General

Engineering Plan Checklist

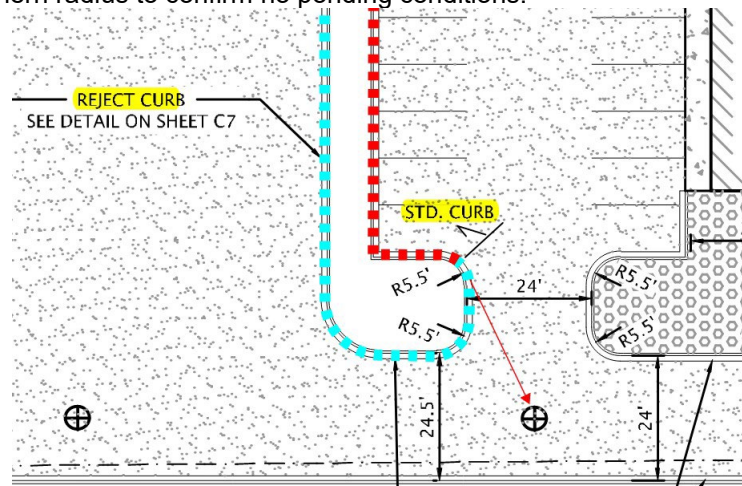
26. Verify grade break between southwest paved area & parking lot is accurately placed. Confirm spot elevations are accurate & provide additional spot elevations to determine grading.

Comment incorporated.
